**[Docket No. FAA-2023-0672; Project Identifier AD-2022-01429-T; Amendment 39-22470; AD 2023-12-12]**

#### **Airworthiness Directives; The Boeing Company Airplanes**

**ACTION:** Final rule.

**Figure 1 to paragraph (g)(2)(i) – Fundamental Effective Isotropic PSD  
at Outside Interface of Aircraft Antenna**

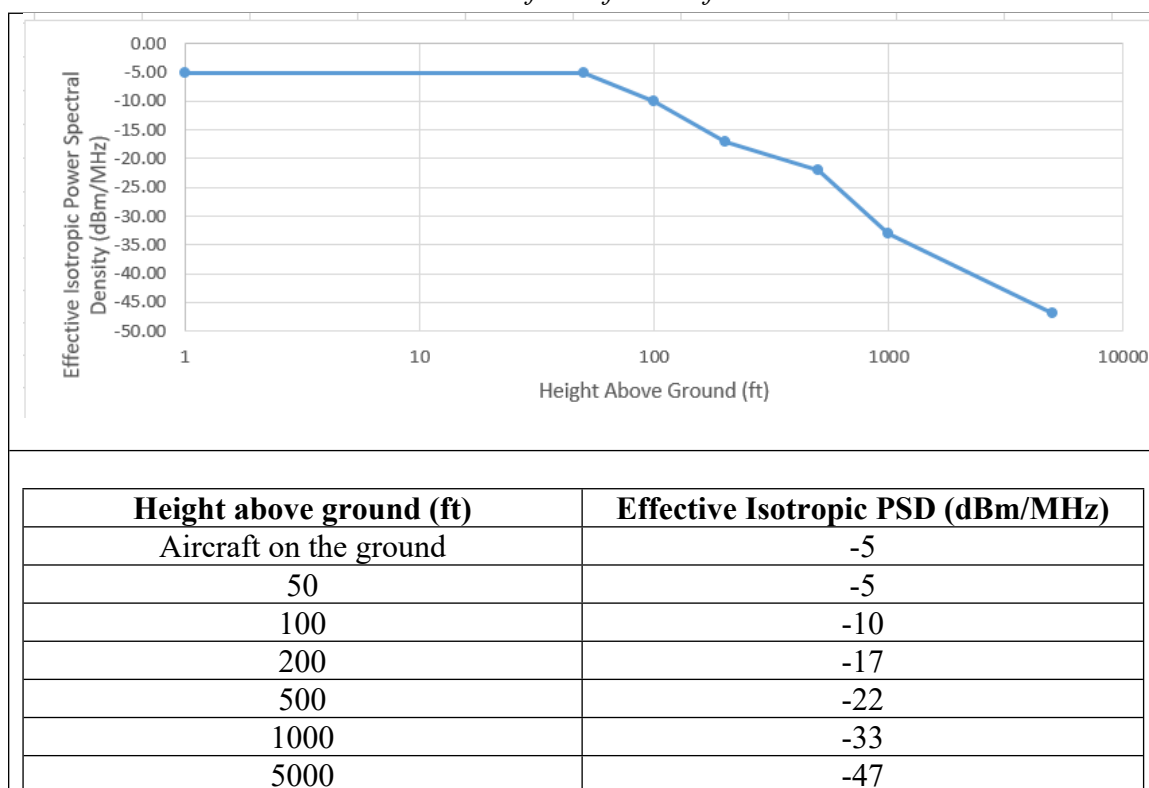
(i) Tolerance to radio altimeter interference, for the fundamental emissions (3.7-3.98 GHz), at or above the power spectral density (PSD) curve threshold specified in figure 1 to paragraph (g)(2)(i) of this AD.

**Figure 2 to paragraph (g)(2)(ii) – Spurious Effective Isotropic PSD at Outside Interface of Aircraft Antenna**

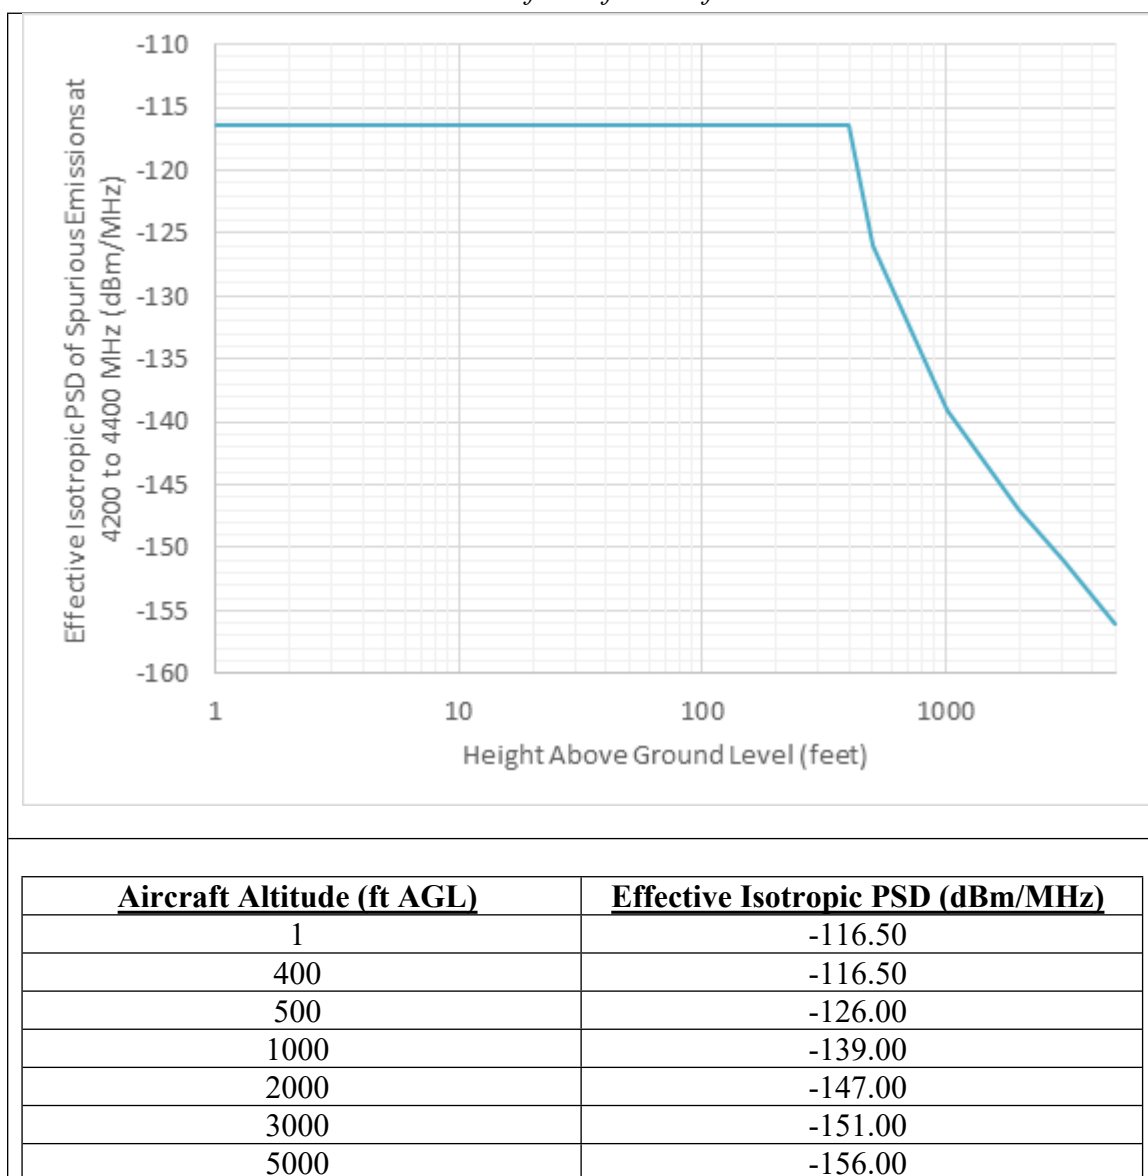
(ii) Tolerance to radio altimeter interference, for the spurious emissions (3.7-3.98 GHz), at or above the PSD curve threshold specified in figure 2 to paragraph (g)(2)(ii) of this AD.
